Amendment to the Drawings

SWITCHABLE FLUID CONTROL VALVE
SYSTEM

Docket No.: 89190.106903 (DP-309416)

FIG. 3

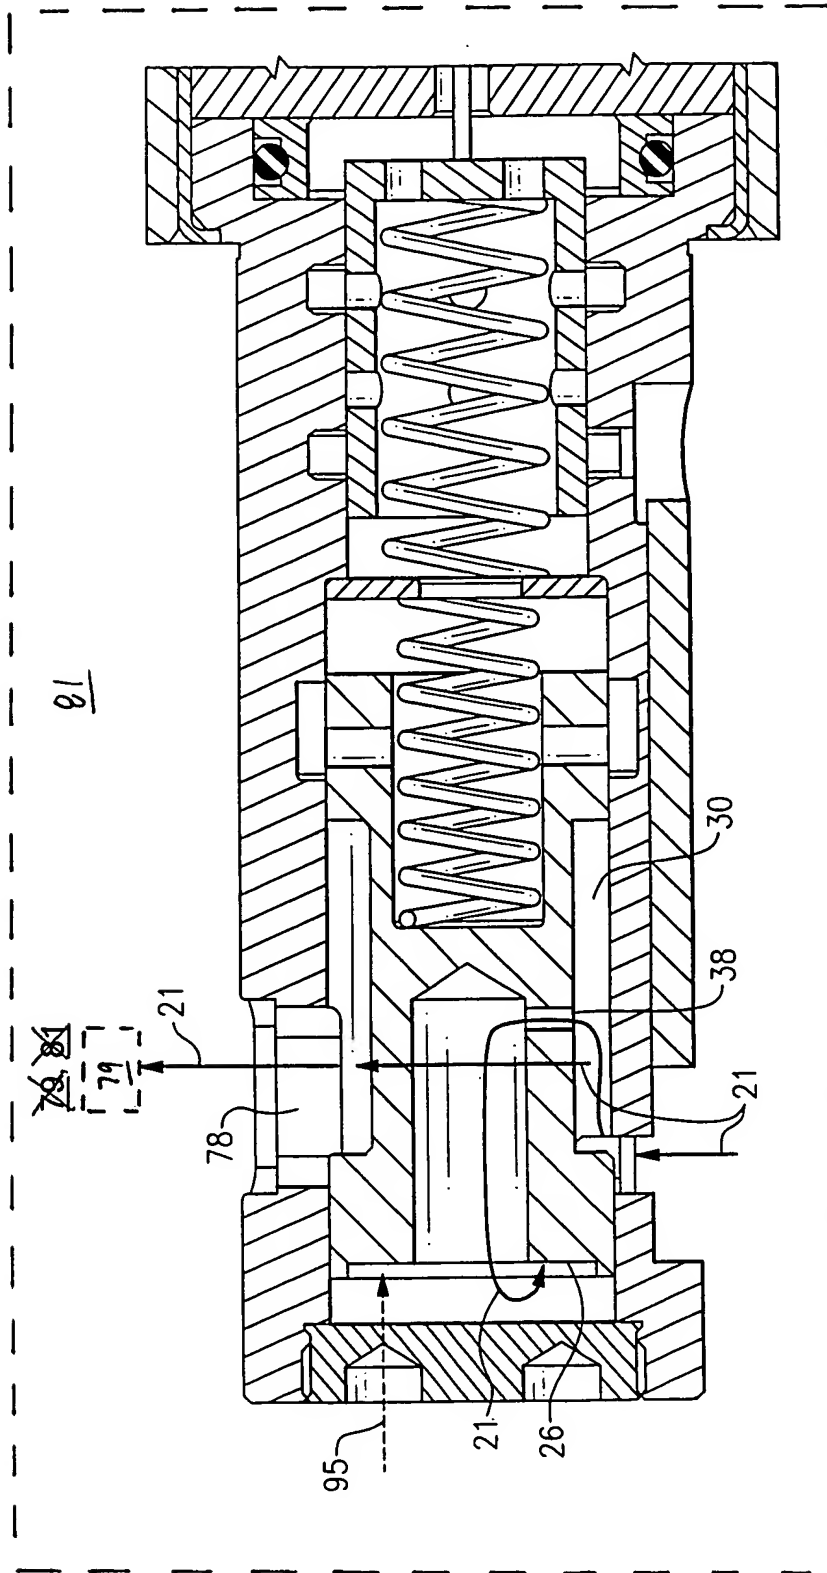
The attached drawing sheet includes a change to FIG. 3. This sheet, which includes FIG. 3, replaces the original sheet including FIG. 3. In Figure 3, the internal combustion engine (81) and the two-step valve activation mechanism (79) have been shown schematically using boxes.

The drawings were objected to under 37 C.F.R. § 1.83(a) because the drawings must show every feature of the invention specified in the claims. See *Office Action*, pg. 2. In particular, the Examiner stated that the internal combustion engine and the two-step valve activation mechanism specified in claim 10 must be shown in the drawings. See *id.* Applicant submits that the internal combustion engine and the two-step valve activation mechanism are shown in original FIG. 3 and are labeled with reference numerals 81 and 79, respectively. See FIG. 3; see also *Specification*, pg. 7, lines 6-10. In an effort to further show the internal combustion engine and the two-step valve activation mechanism in the drawings, FIG. 3 has been amended to schematically show the two-step valve activation mechanism (79) and the internal combustion engine (81). For at least the aforementioned reasons, Applicant requests that the above-referenced amendments to the drawings be entered and that the objection to the drawings be withdrawn.
